Docket: : A.13-10-020  
Exhibit Number : \_\_\_\_\_  
Commissioner : Liane Randolph  
Admin. Law Judge : Hallie Yacknin  
ORA Project Mgr. : Christopher Myers  
: Barry Flynn  
: Robert Jenkins  
: Pushkar Wagle

**OFFICE OF RATEPAYER ADVOCATES**  
**CALIFORNIA PUBLIC UTILITIES COMMISSION**

**PREPARED TESTIMONY ON**  
**THE APPLICATION OF SOUTHERN CALIFORNIA EDISON**  
**COMPANY (SCE) FOR A CERTIFICATE OF PUBLIC**  
**CONVENIENCE AND NECESSITY FOR THE WEST OF**  
**DEVERS UPGRADE PROJECT AND FOR AN INTERIM**  
**DECISION APPROVING THE PROPOSED TRANSACTION**  
**BETWEEN SOUTHERN CALIFORNIA EDISON AND**  
**MORONGO TRANSMISSION LLC**

October 27, 2015

1 **Figure 1: Forecast Supply and Demand 2015-2034**<sup>44</sup>

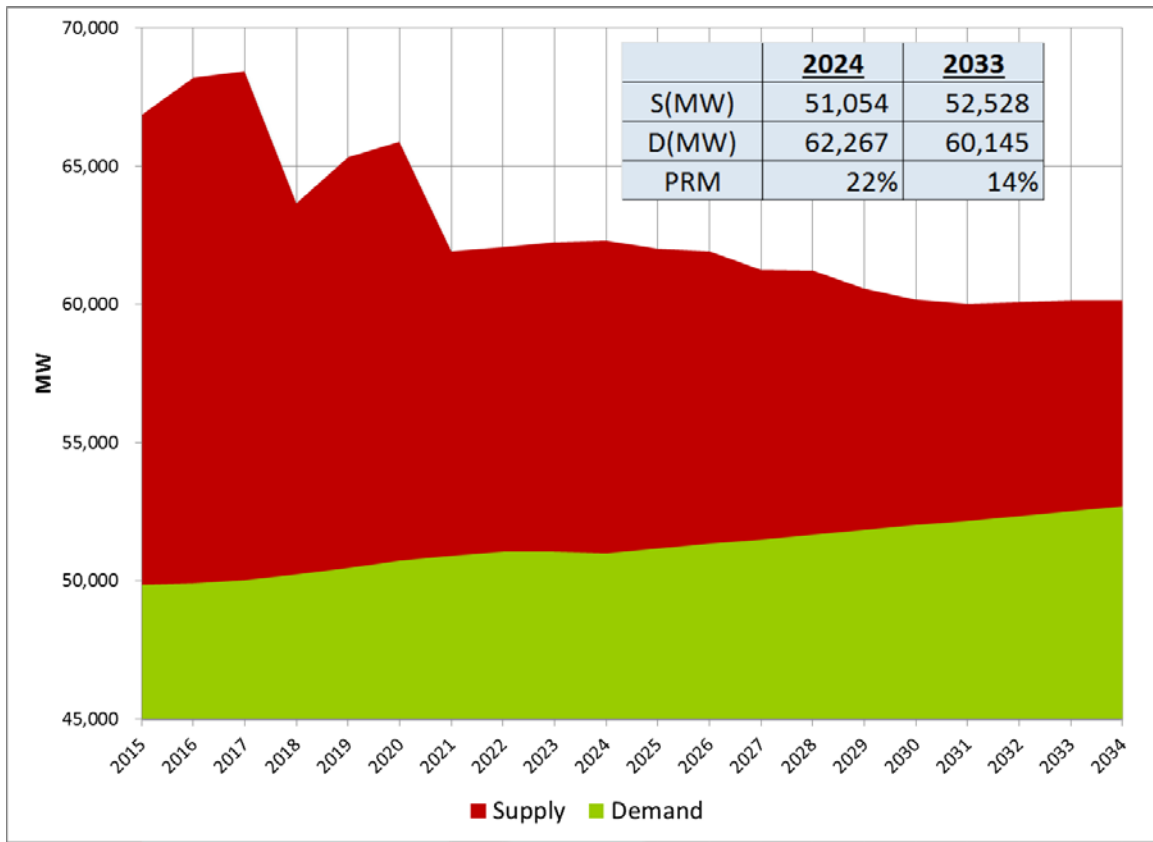
5         Currently, the market has more capacity than is needed to meet the System  
6 RA requirements over the 10 year planning horizon. The most basic evidence of  
7 excess system capacity is the 2014 Long Term Procurement Plan (“LTPP”) load  
8 and resources balance analysis shown in **Figure 1** below. The planning margin for  
9 system-wide reserves peaks in 2016 at 37% and then is about 22% in 2024.<sup>43</sup>

3 As can be seen from Figure 1, the CPUC 2014 LTPP does not identify need

7 System RA resources available that are not shown in Figure 1. In particular, these

**Figure 2: Marginal ELCC of Solar Resource Drops Significantly with Increasing Penetration<sup>54</sup>**

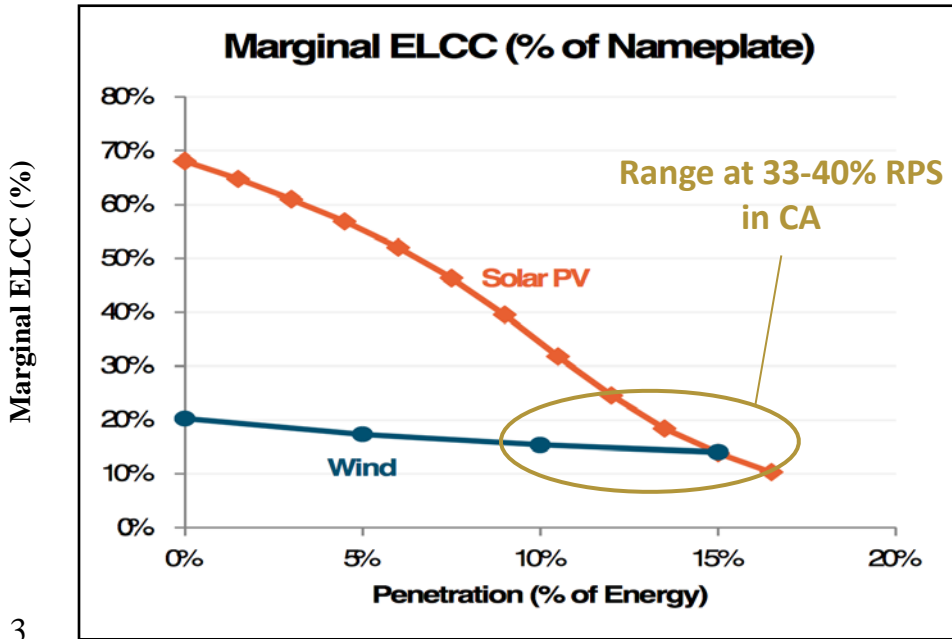
1           In support of this requirement, the CPUC’s Energy Division staff has  
2 developed a calculation methodology for the CPUC’s determination of the ELCC  
3 and QC of wind and solar resources.<sup>53</sup> The marginal ELCC of a specific  
4 renewable resource technology declines as its penetration increases. This is most  
5 apparent for solar PV, which has a high capacity credit at low penetrations, but  
6 this rapidly decreases as additional capacity is added. See **Figure 2** below. To  
7 place this effect in context, consider that a small level of solar generation can  
8 reduce the net peak load at mid-day. However as more solar is added, the net peak  
9 load begins to shift to the evening hours when solar is not available to offset load.  
10 In such a situation, adding more solar generation does little to support system  
11 capacity needed to serve the shifted peak load.
